Access Compliance Report Public Rights-of-Way (Pedestrian Signals)

Intersection ID: N/A	Main Street:	Cross Street: N/A	Location: N/A
ADA ID: 21B5B145F8EE	Signal Type: One Push Button-Non APS	Overall Compliance: No	Severity Score: BTN 1: N/A BTN 2: N/A No BTN: N/A
Codes/Mitigation Info/Possible Solution		Field Measurements/Component Compliance

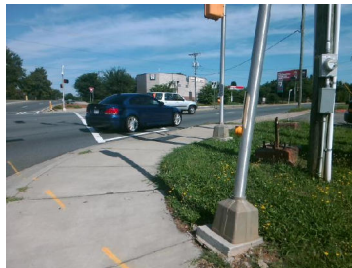
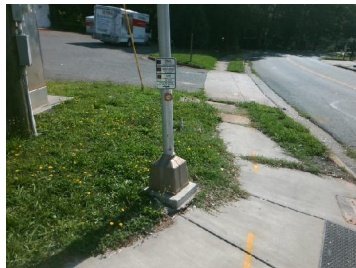
Surveyor Notes: TEXT HT 1/2

PROW/ADA: R410.6, R209.1, TMUTCD 4e.08, R404.2, R404.3, R406.2, R404.7.3

Possible Solutions: Replace Signal Push Button With APS Button on New Post. Remove & Replace Sign.
